ADDENDUM NO. 1

ISSUE DATE: **September 05, 2024**

RE: **CHAMBERLIN L&S SONGS PHYSICS LAB RENOVATION
UNIVERSITY OF WISCONSIN-MADISON
MADISON, WISCONSIN**

UW-Institution Project No. 0055-2346
UWSA Project No. A-23-012

2
E211
NEW WORK PLAN - LEVEL 04 - POWER/SYSTEMS
SCALE: 1/8" = 1'-0"

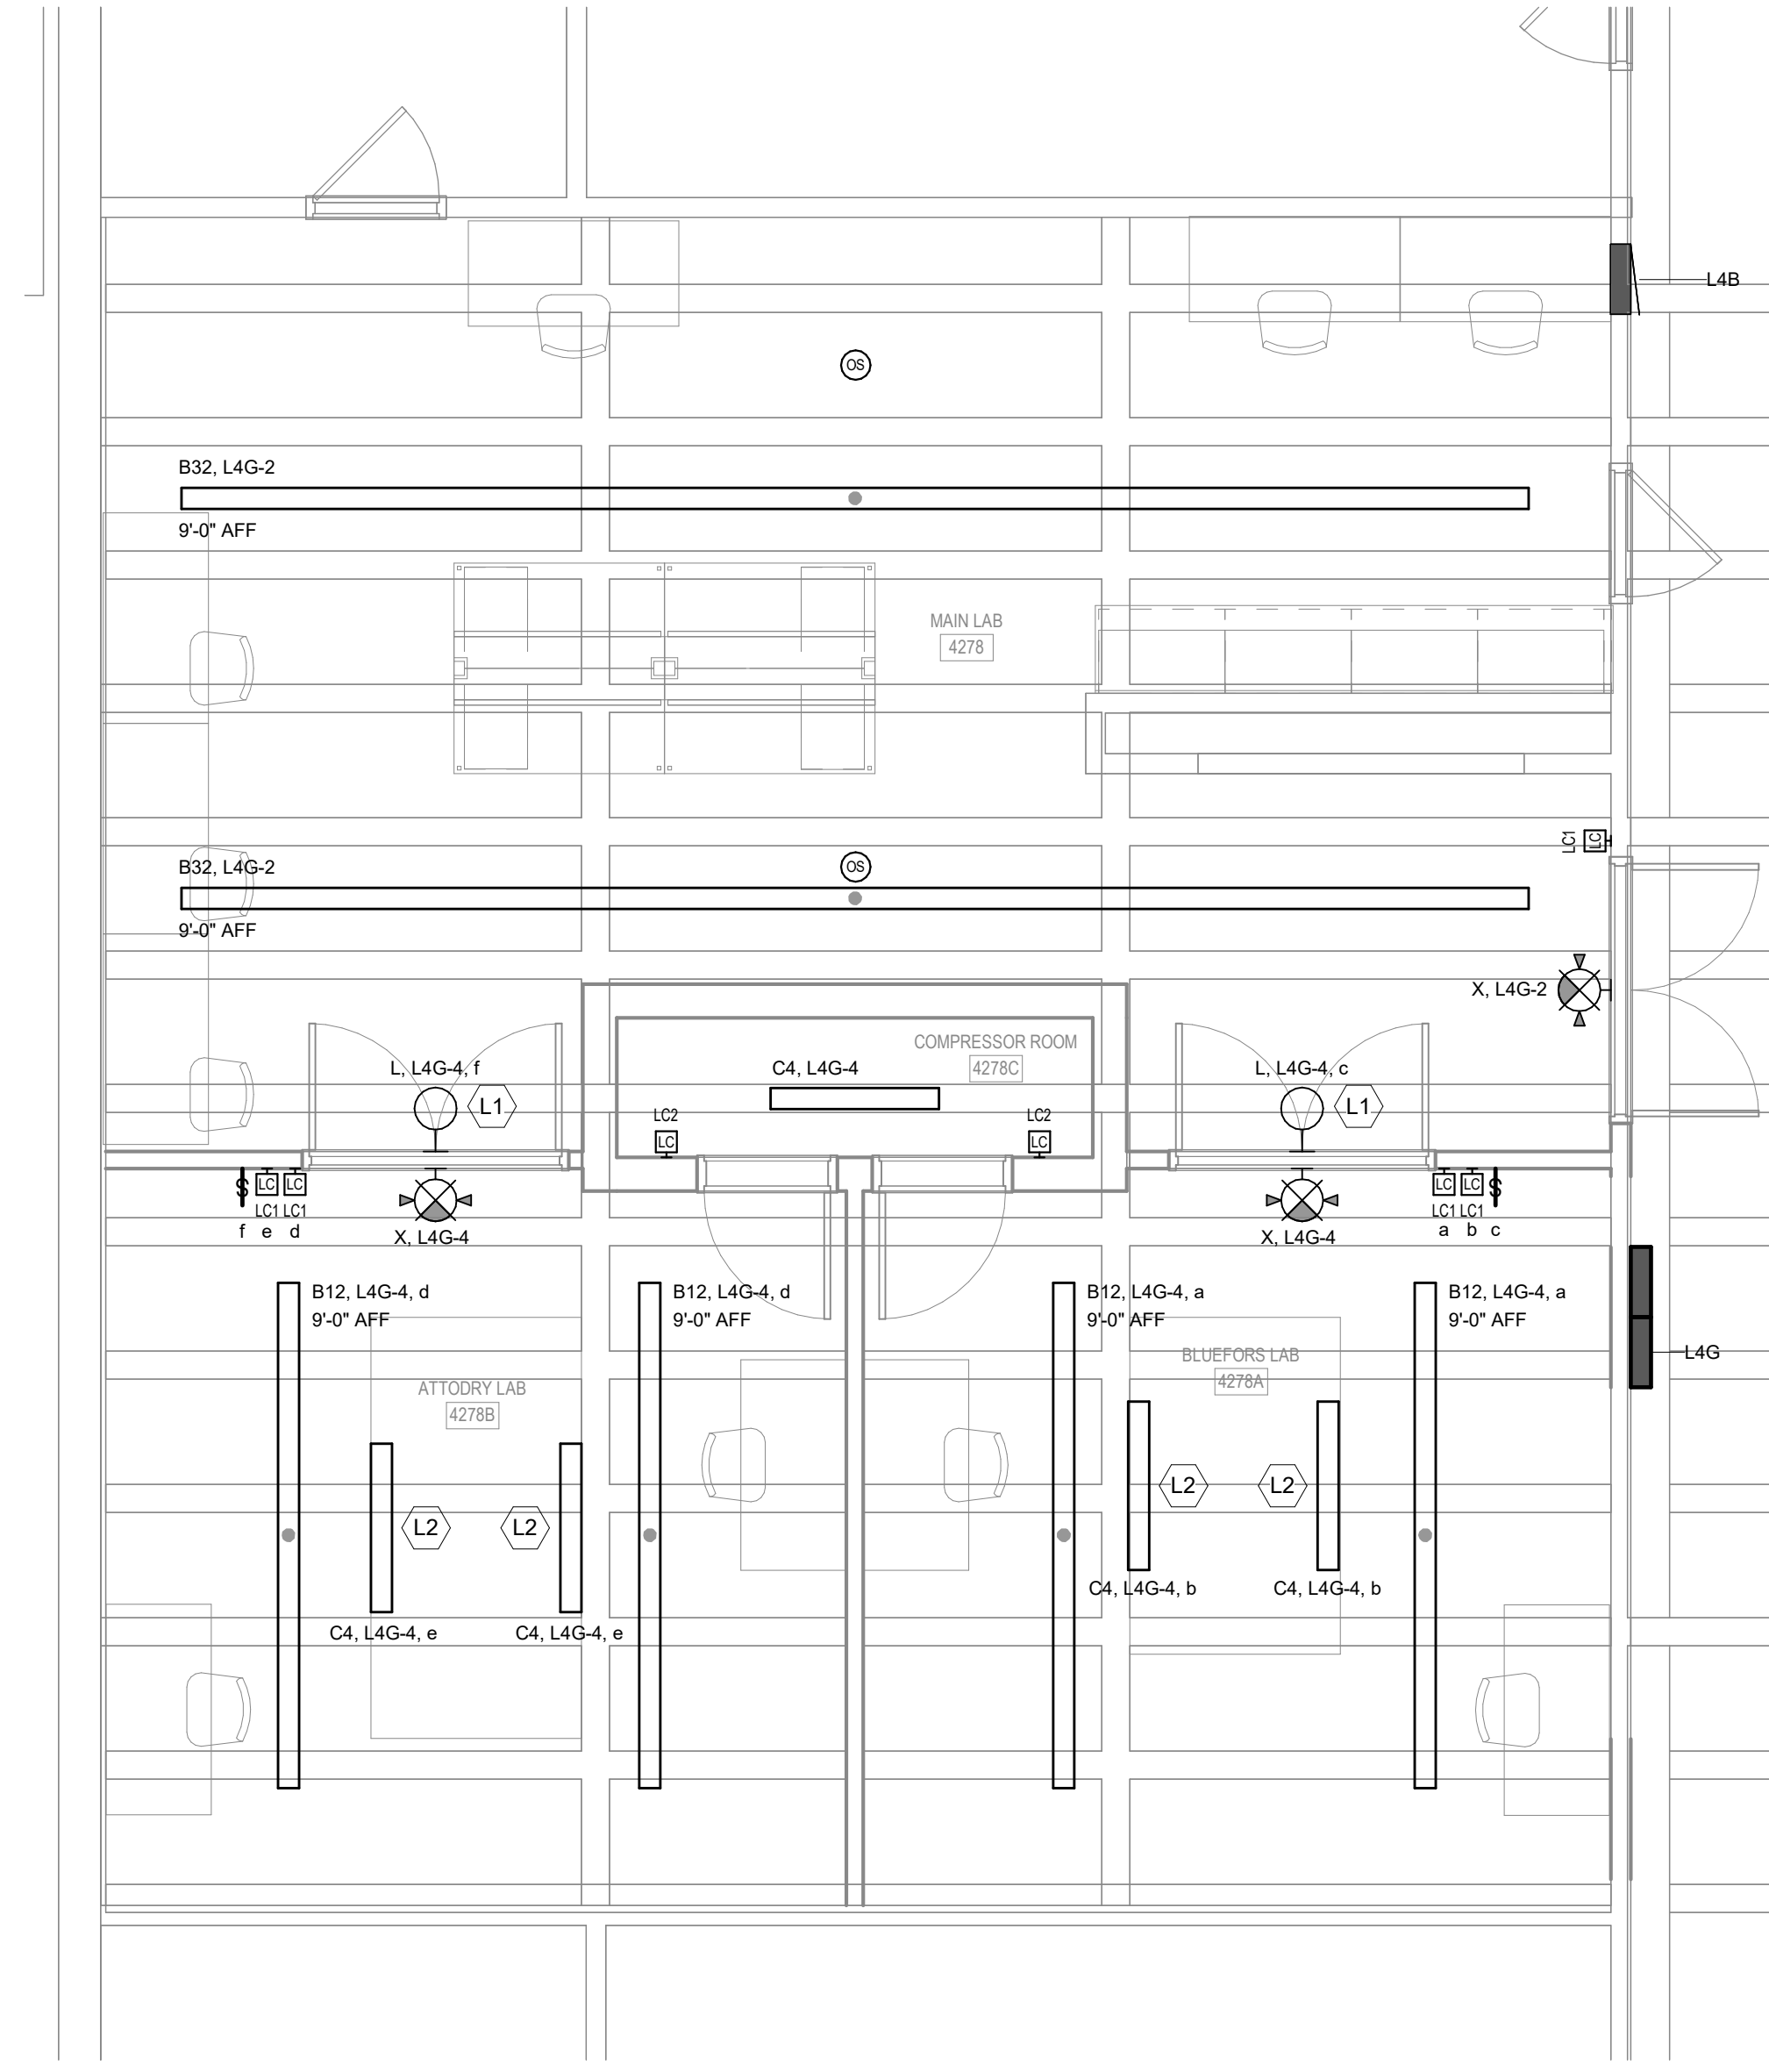
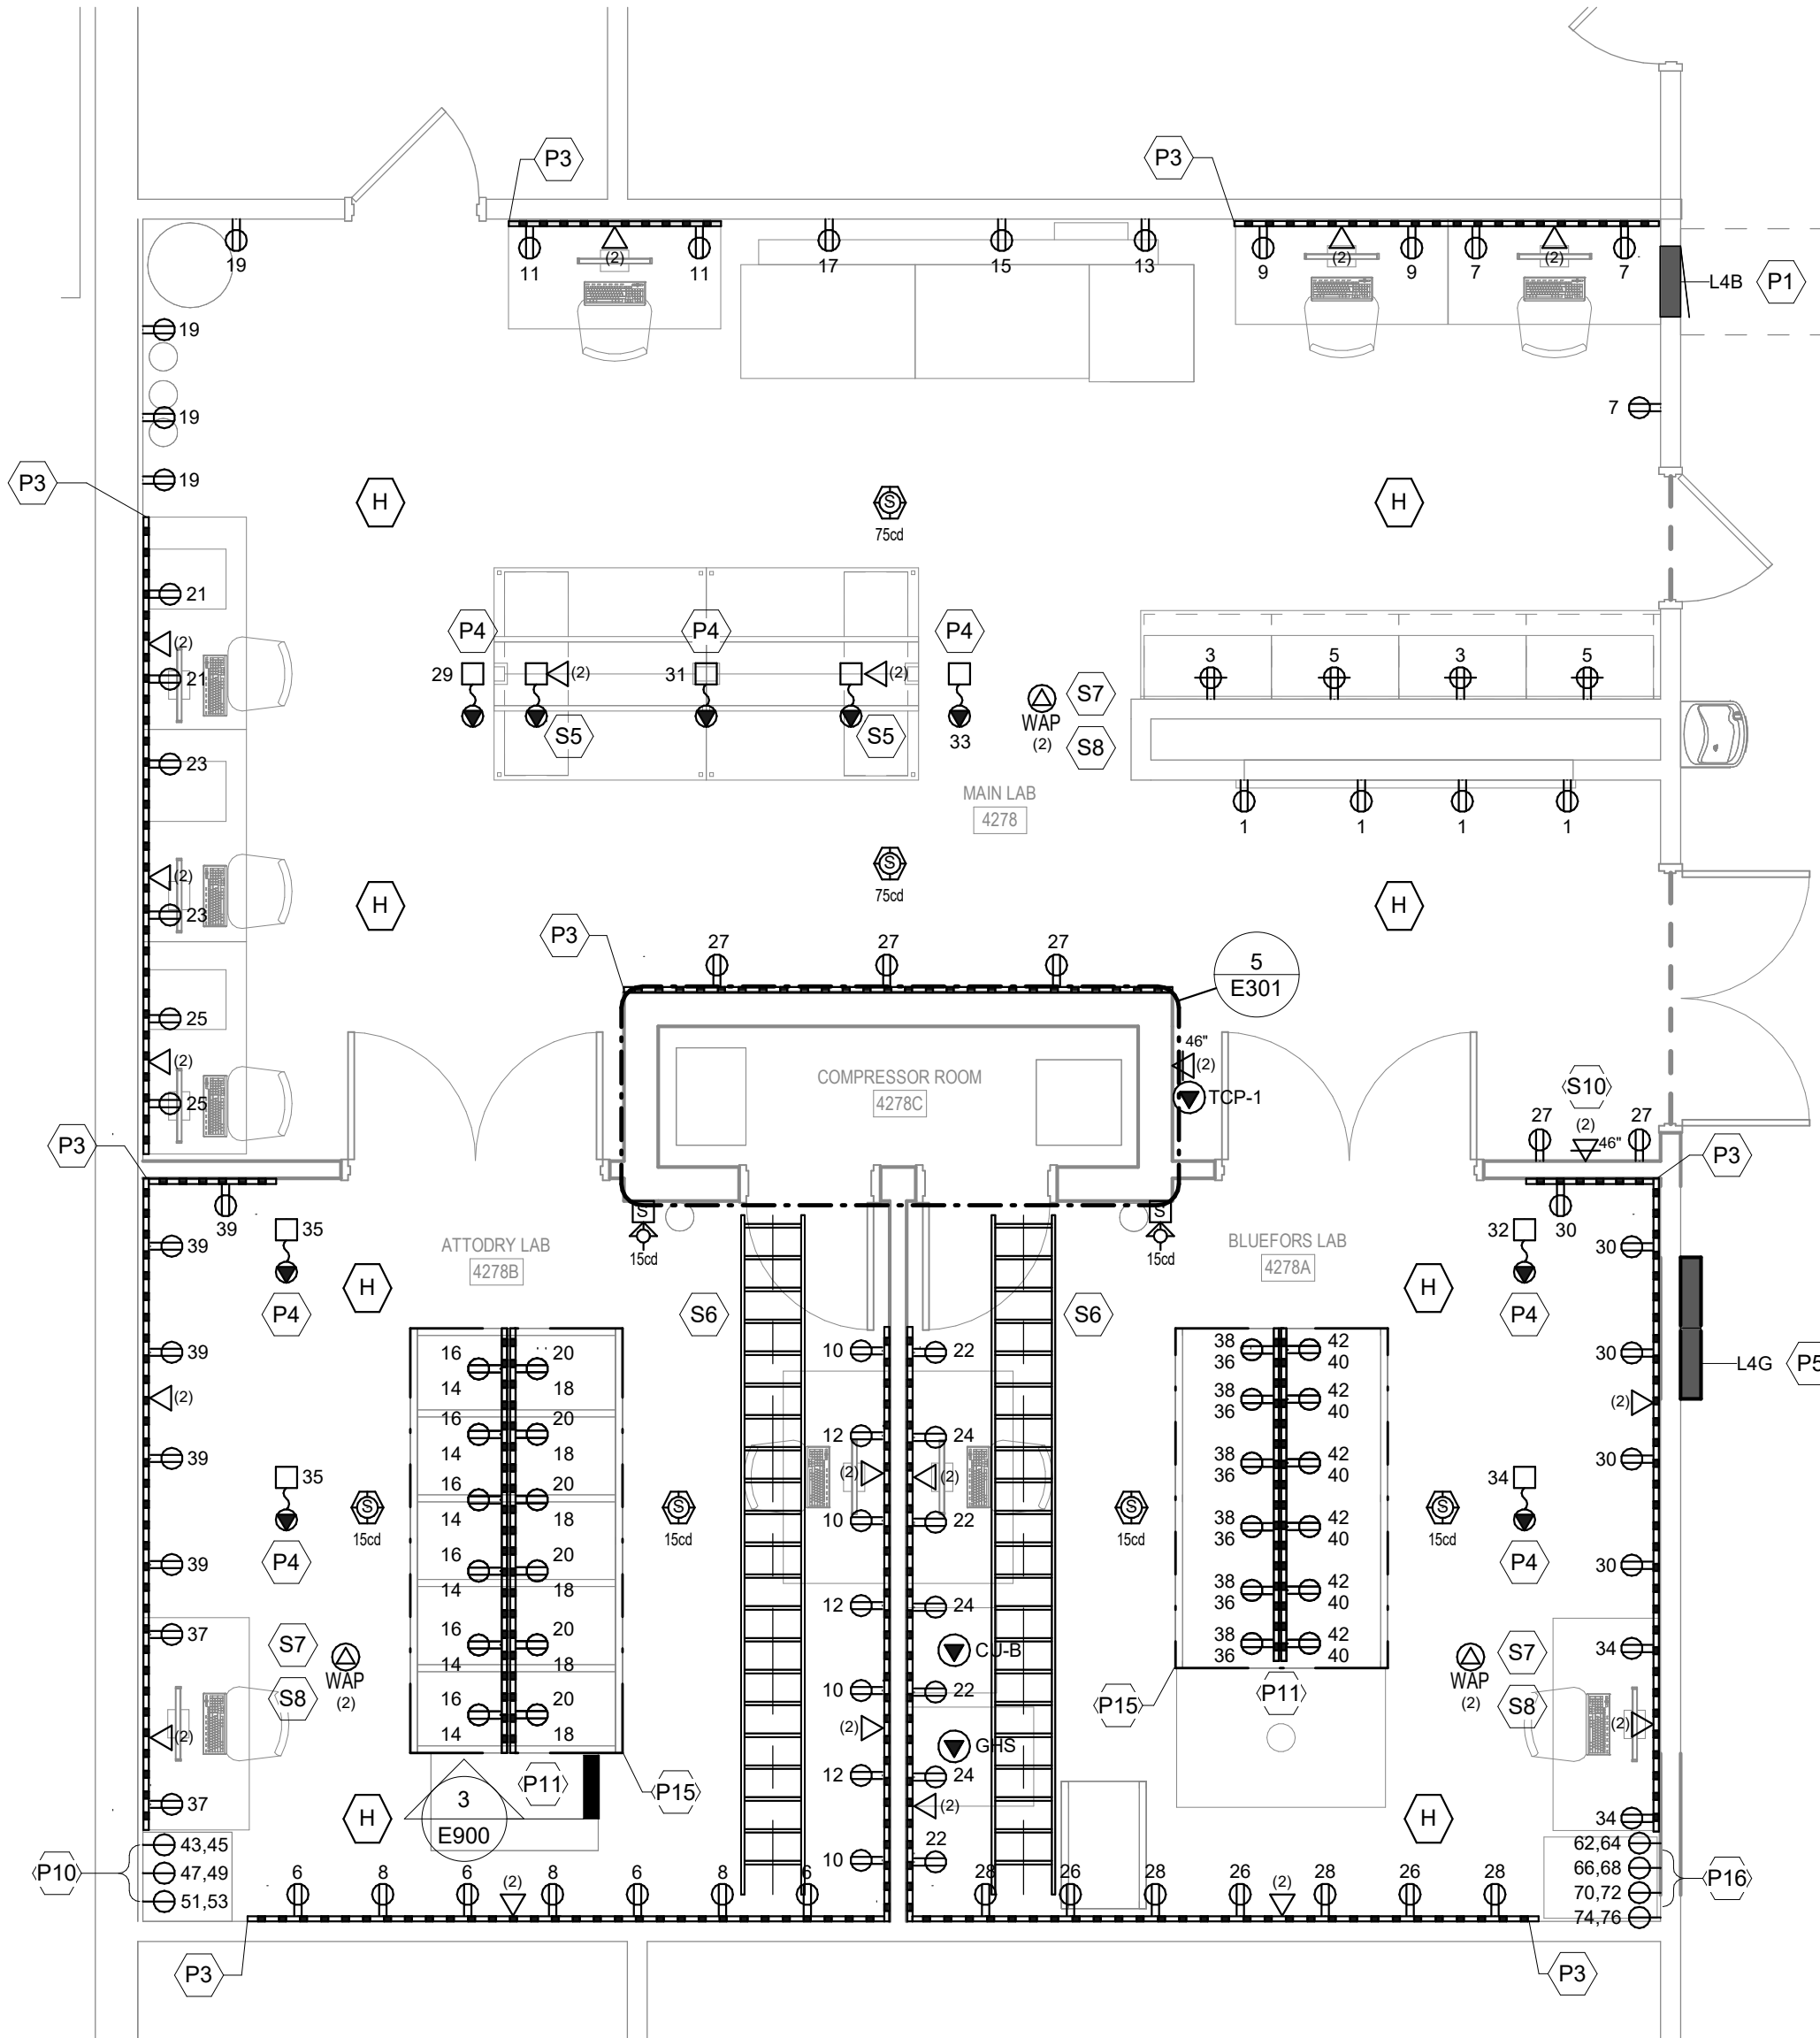
1. Sheet A101 – DEMOLITION PLAN – LEVEL 03
 - a. Add demolition plan keynote 20.
2. Sheet A102 – DEMOLITION PLAN – LEVEL 04
 - a. Add demolition plan keynote 20.
3. Sheet E201 – NEW WORK PLAN – LEVEL 03 - ELECTRICAL
 - a. Revise power general note to clarify the number of current carrying conductors allowed to be installed in a single conduit prior to conductor derating.
4. Sheet E211 – NEW WORK PLAN – LEVEL 04 - ELECTRICAL
 - a. Revise power general note to clarify the number of current carrying conductors allowed to be installed in a single conduit prior to conductor derating.

- THE CONTRACTOR MAY INSTALL UP TO THREE (3) CURRENT CARRYING CONDUCTORS IN A CONDUIT, WHEN UTILIZING ONLY #12 CONDUCTORS, THE CONTRACTOR MAY INSTALL UP TO SIX (6) CURRENT CARRYING CONDUCTORS IN A CONDUIT. LOADINGS ARE BASED ON THW IN INSULATION, 40°C AMBIENT WITH DERATING FOR TEMPERATURE AND UP TO THREE (3) CONDUCTORS IN A CONDUIT. CONTACT THE ENGINEER FOR WIRING IN OTHER CONDITIONS TO ACCOUNT FOR CONDUCTOR DERATING. NEUTRAL CONDUCTOR SHALL BE CONSIDERED A CURRENT CARRYING CONDUCTOR IN UNBALANCED 3-PHASE APPLICATIONS.
